Access Compliance Report

Public Rights-of-Way

Intersection ID: 22936	Main Street: CHESSEL_PL	Cross Street: GORDONVALE_PL	Location: SE
ADA ID: 9A01FFF6EFD3	Ramp Type: PerpDiag	Initial Pass/Fail: Fail	Overall Compliance: No
Severity Score: 25			
Codes/Mitigation Info/Possible Solution		Field Measurements/Component Compliance

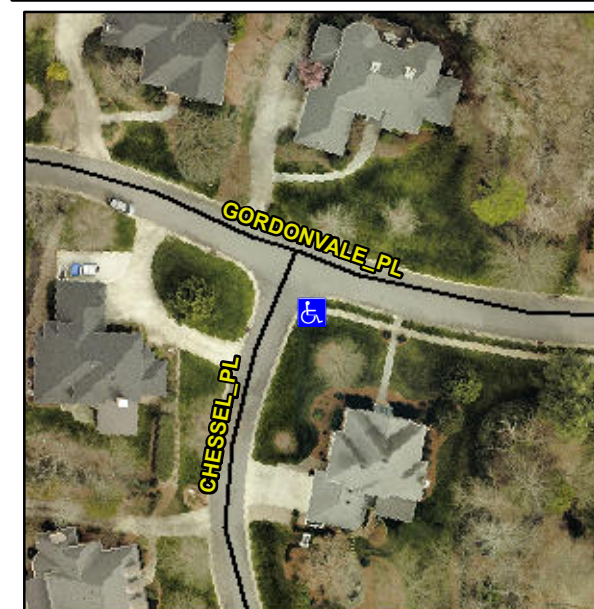
Remove & Replace Curb Ramp With Two New Directional Ramps or Equivalent.

R304.5.3
